Landmarks Preservation Commission

May 5, 2026
Public Meeting

Preservation Department – Item 3, LPC-25-07016

41-43 Mercer Street – SoHo-Cast Iron Historic District

41 Mercer Street: Original Proposed and Revised Elevations

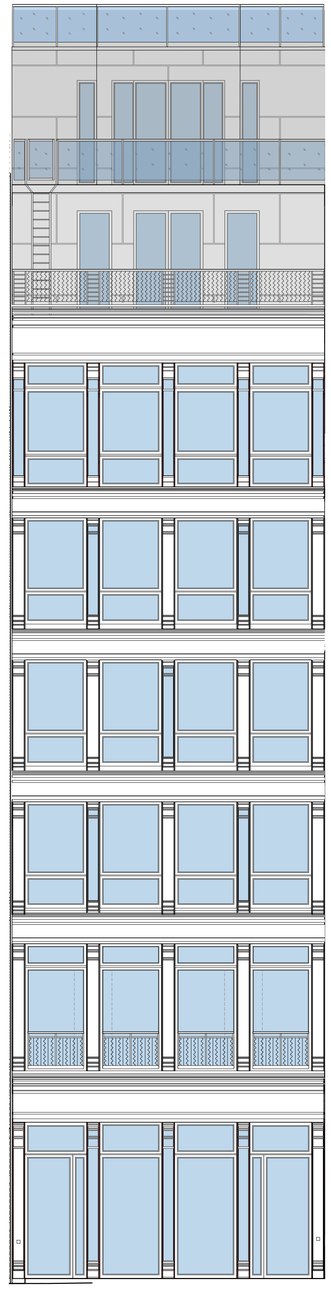
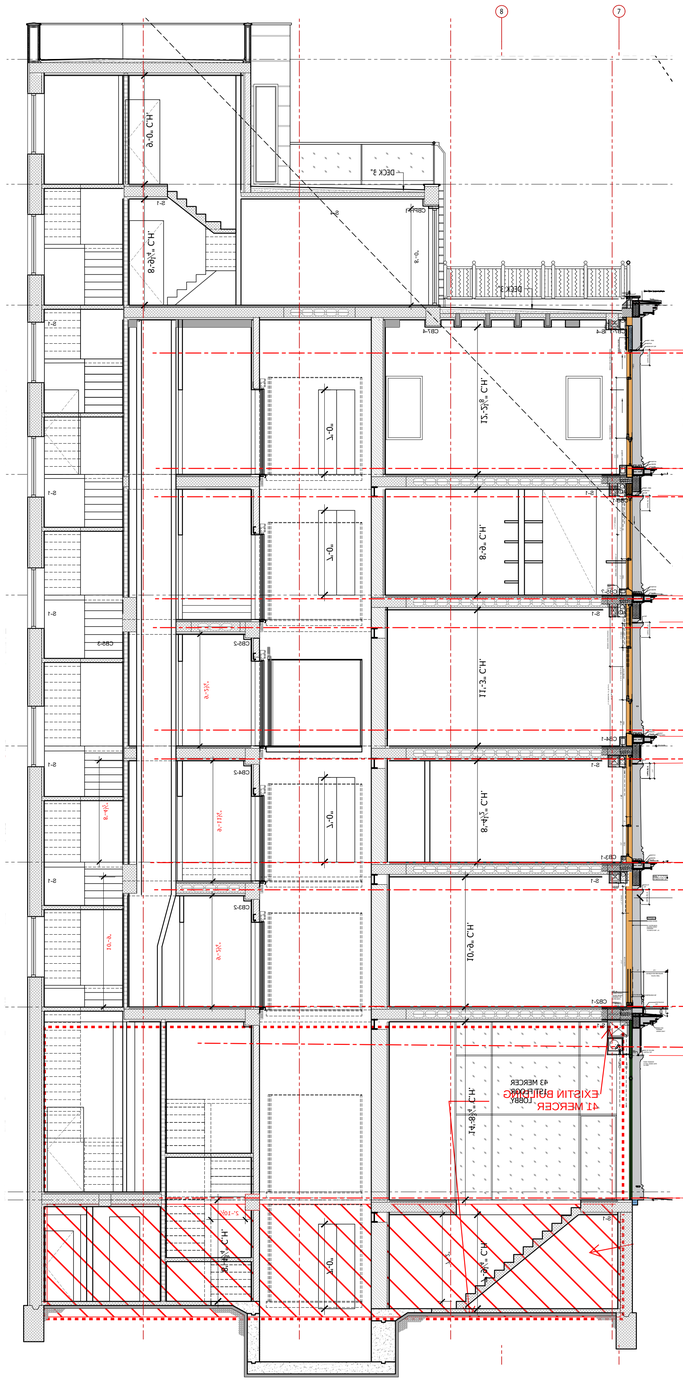
Commissioner Consensus at Public Hearing 2/24/26 :

1) Don’t vary floor heights. Floor heights, as reflected by the fenestration, should be uniform, or should taper toward the top of the building.

2) Revise the balcony so that it integrates into the façade.

3) Add a pigeon prevention method.

Front Elevation Previously Proposed at Public Hearing 02/24/26

Front Elevation Current Proposed Design 05/05/26

43 Mercer Street: Proposed Design Revisions

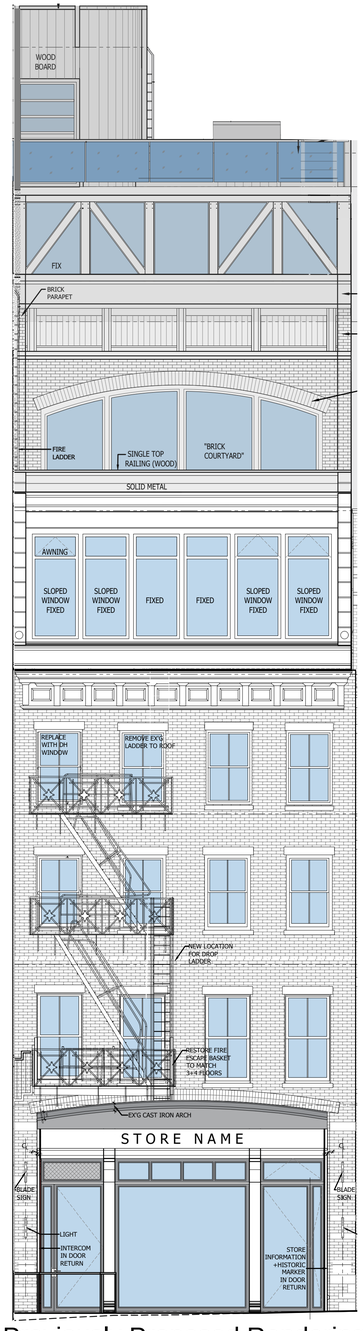
Commissioner Consensus at Public Hearing 2/24/26 :

1) Refine the details of the atelier window. Reduce and simplify the rooftop addition.

2) Redesign the rear facade so that it has a relationship to the front facade.

3) Add a bulkhead at the storefront window.

Previously Proposed Rendering from Public Hearing 02/24/26

Current Proposed Design Rendering 05/05/26
